BNE Energy, Inc. Petition For a Declaratory Ruling That No Certificate of Environmental Compatibility and Public Need Is Required for the Construction, Maintenance, and Operation of a 4.8 MW Wind Renewable Generating Facility Located on Flagg Hill Road, Colebrook, Connecticut.

Petition 983

PETITION 983: BNE ENERGY, INC.'S RESPONSE TO THE CONNECTICUT SITING COUNCIL'S JANUARY 24, 2020 D&M INTERROGATORIES

C002

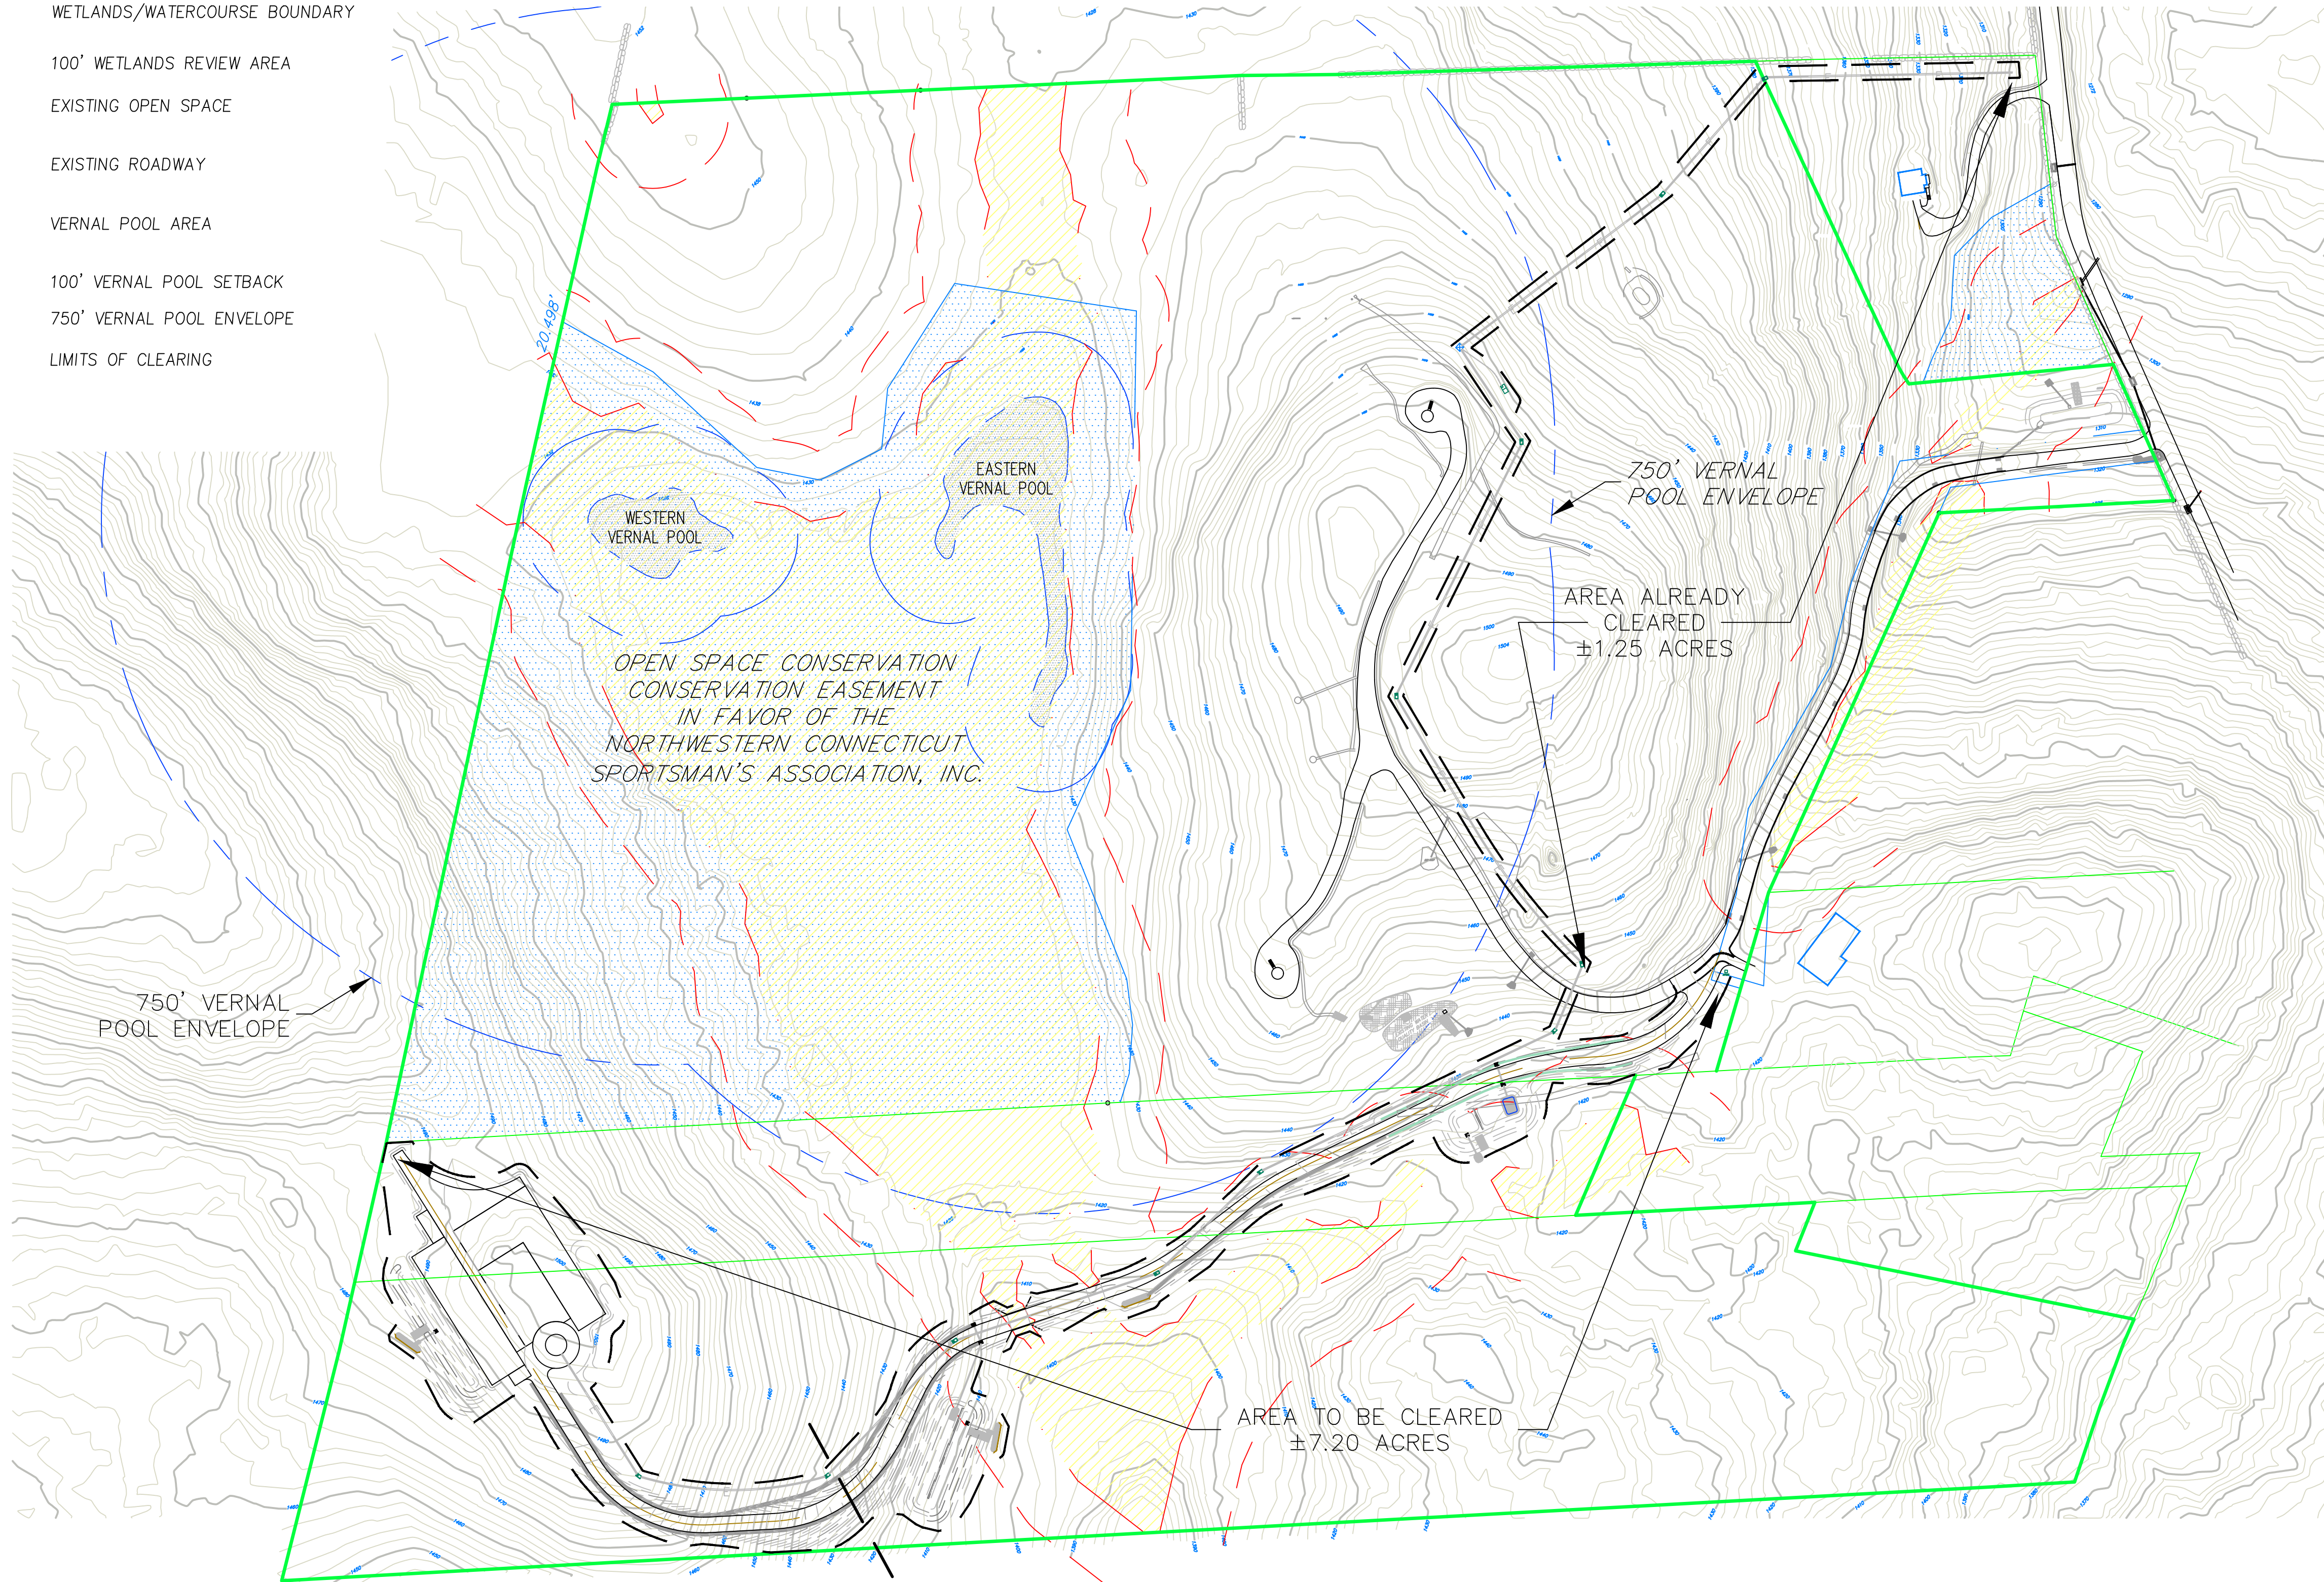
- 13. Page 1 of the D&M Plan Modification states, “BNE also has an option to purchase approximately 9.95 acres located at 45 Flagg Hill Road...” Drawing C001 also depicts the 9.95 additional acres directly to the south of the original site property. Referencing Tab C of the D&M Plan Modification, Purchase Option Agreement for 45 Flagg Hill Road, Colebrook, it states that the property from Option or consists of approximately 9.27 acres of land. Exhibit B to the Purchase Option Agreement – Map of Property also depicts 9.27 acres based on the “Property Line in Purchase Option.” Please reconcile the 9.95 acres with the 9.27 acres.**

Answer: The Purchase Option Agreement and Exhibit B are correct regarding the amount of land of approximately 9.27 acres to be purchased by BNE. The D&M drawings have been updated to reflect the correct acreage of the land described in the purchase agreement, and are included with these interrogatory responses. The revision required a slight modification of the access drive alignment and grading in the area of the land to remain with 45 Flagg Hill Road. All other grading of the access drive and turbine pad area, including the wetland crossing, has not been altered from the previous submission.

C302

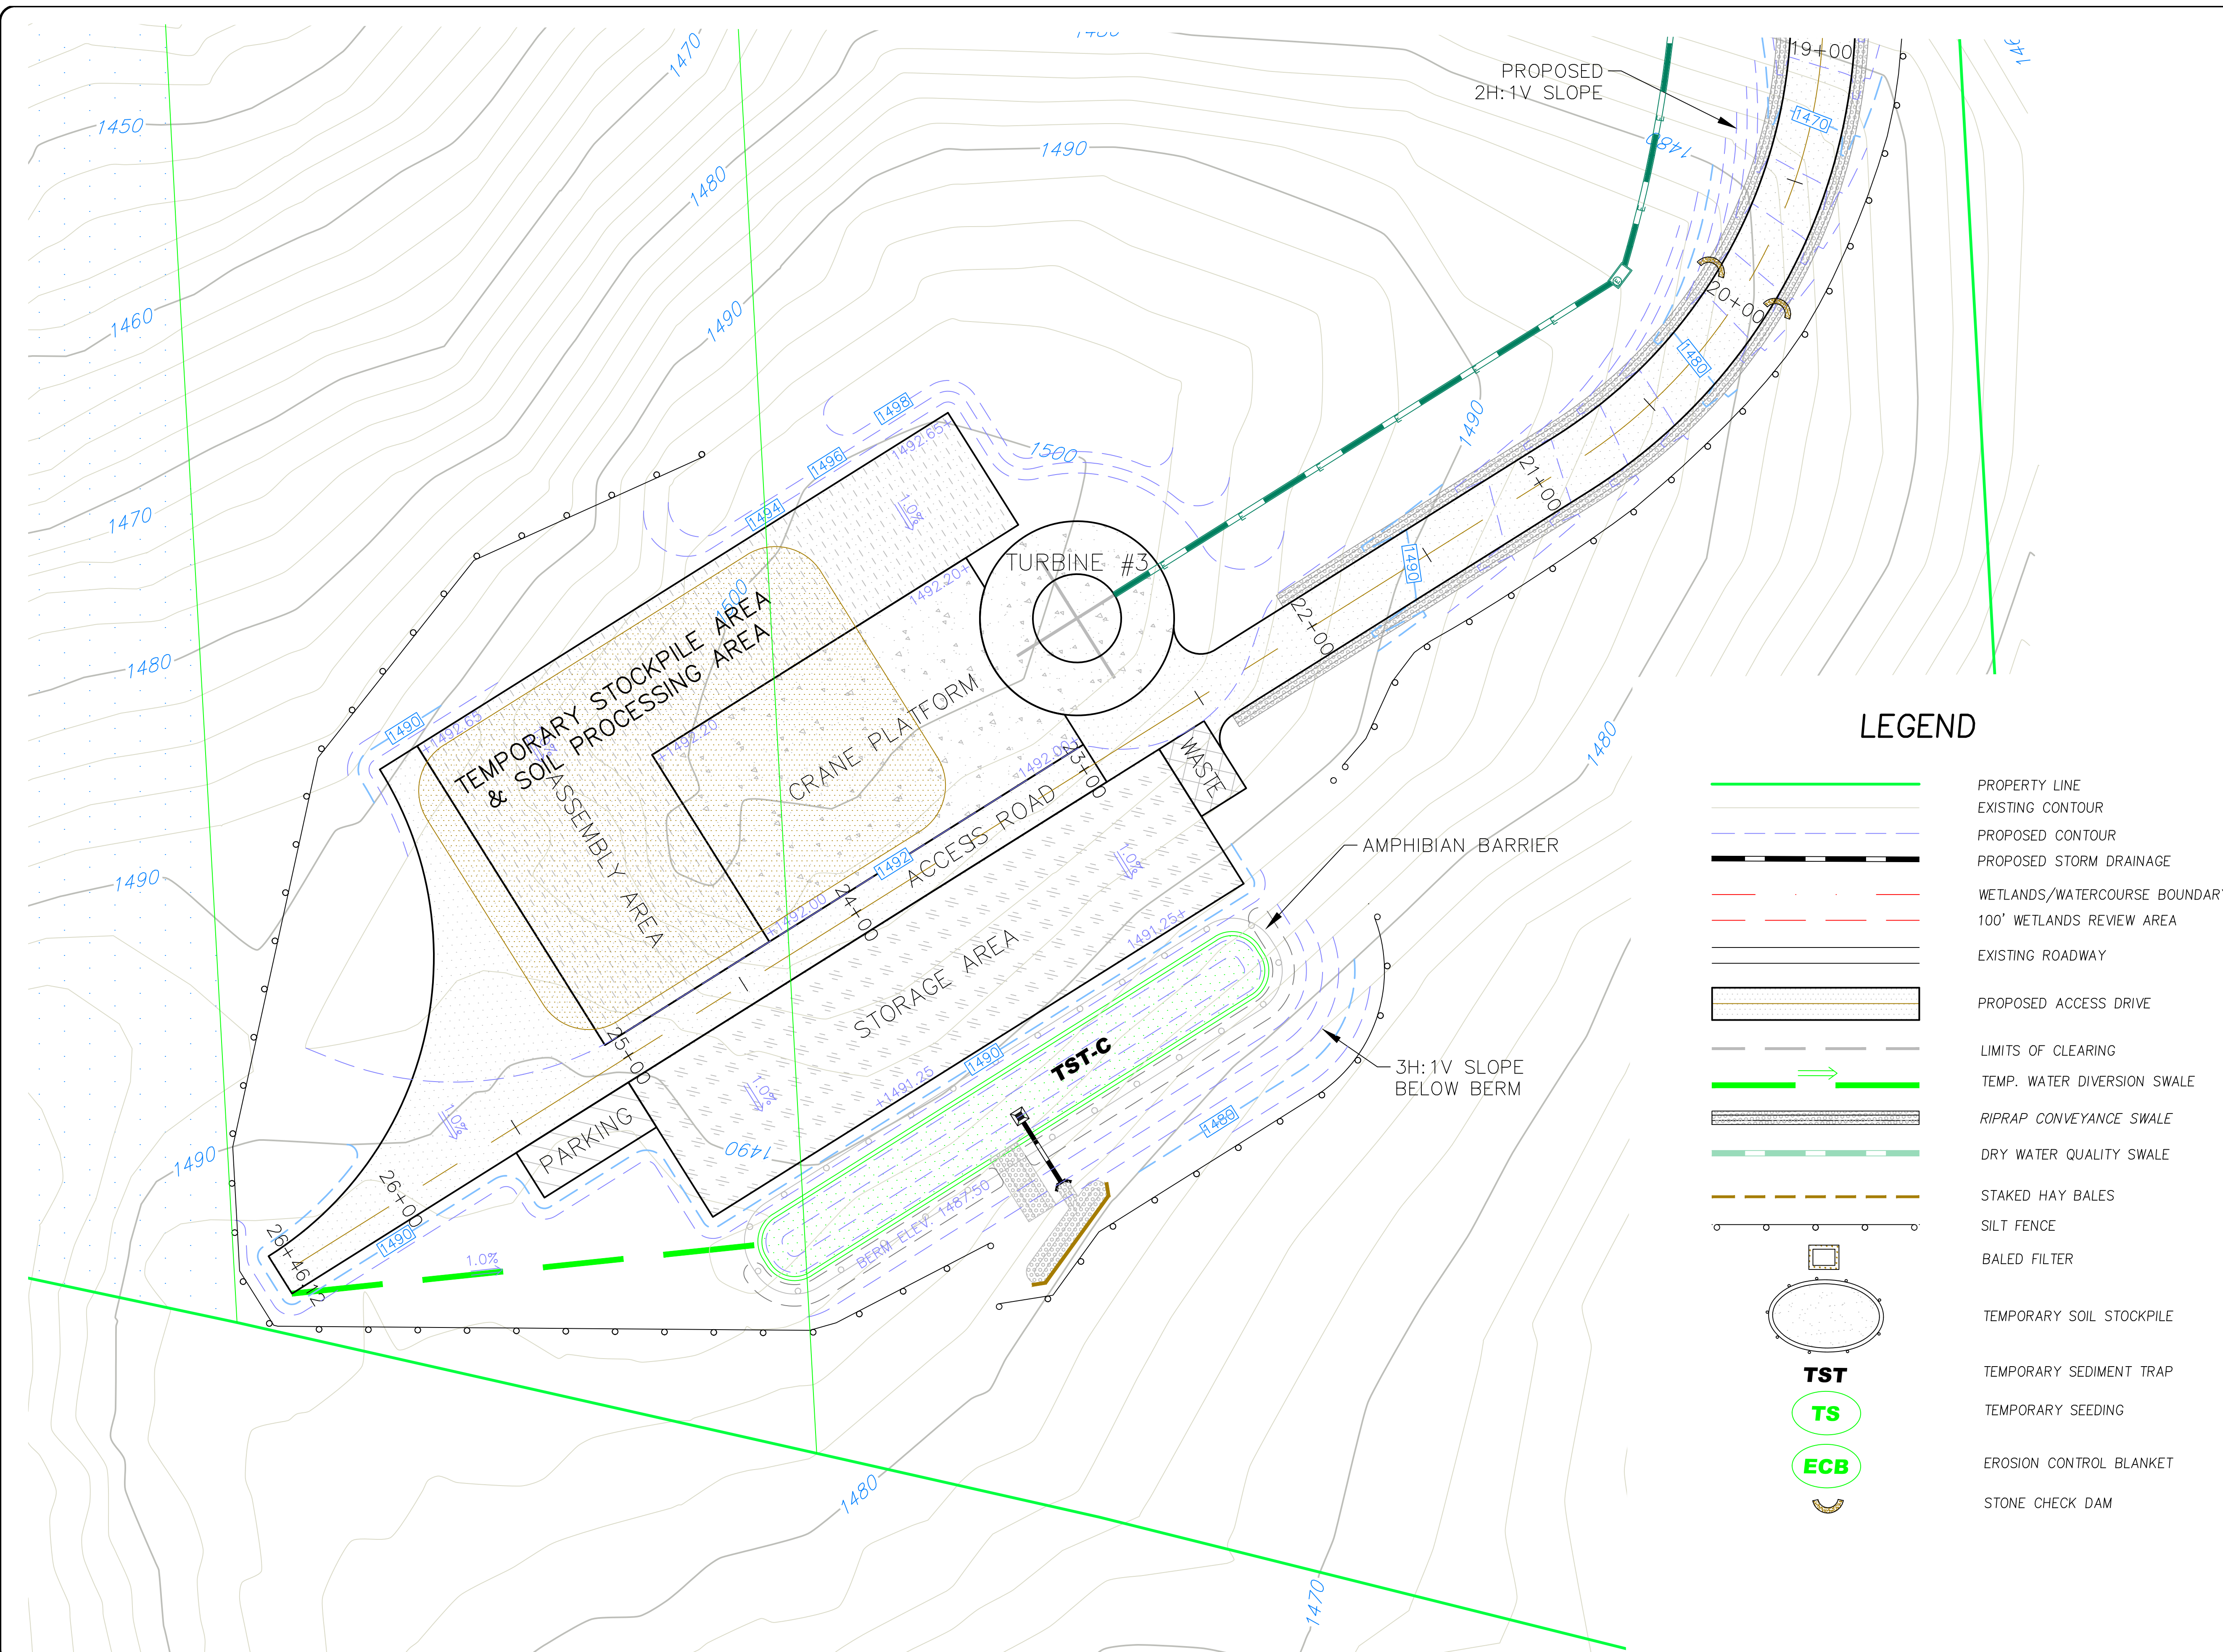
54. Referring to Sheet C302:

- a) The bridge construction area detail shows two separate rows of erosion and control barriers on the south side of the bridge and a single barrier on the north side of the bridge to protect adjacent wetlands. Should a second separate barrier also be installed on the north side?**
- b) How would the wetland area at the bridge location be crossed prior to bridge installation? Provide crossing detail.**

b) Timber matting will be used as a temporary wetland crossing south of the proposed bridge. This measure is in conformance with best management practices outlined by the ACOE and CT DEEP as a temporary wetland/stream crossing for construction. A construction detail has been added to the D&M plans on Sheet C602.

SCALE: N.T.S.
 DATE: 15 NOV 19
 PROJ. NO.: 3092 ARCH D_EJ
 CAD FILE NAME: 3092 ARCH D_EJ
 DRAWING NO.: **C601**

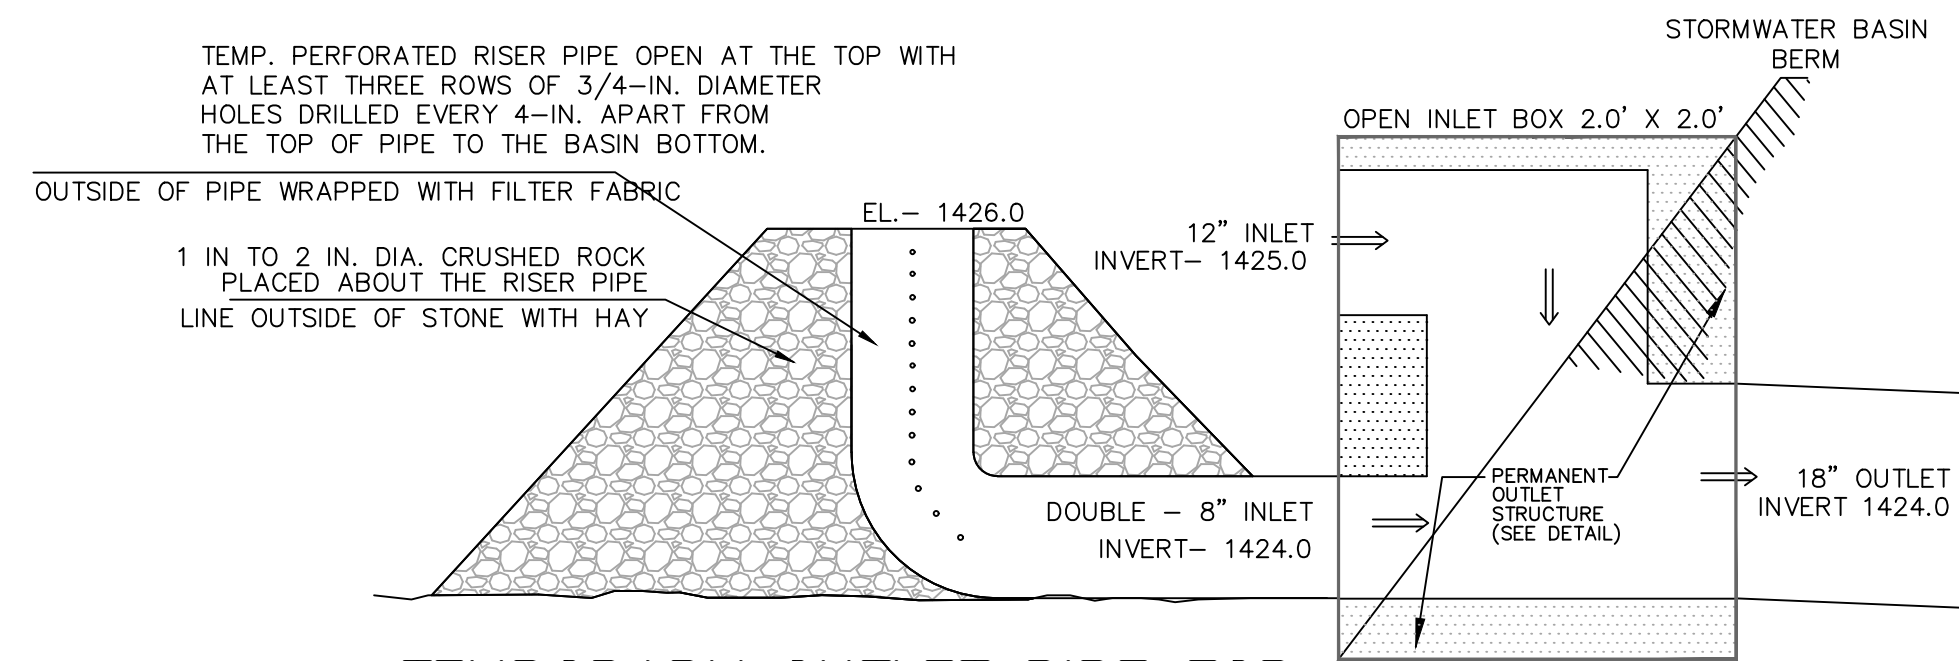
- 56. Referring to Sheet C601: The Temporary Sediment Trap Outlet detail includes an amphibian barrier to be installed as noted on the Site Plans; however, the Site Plans do not have any marking indicating where the barriers would be installed. Please clarify.**

Answer: The proposed amphibian barrier shall be installed around the entirety of the TSTs at the berm elevation. They are constructed of silt fencing material and have been added to the plans on the Erosion Control Sheets (Sheets C300-C303).
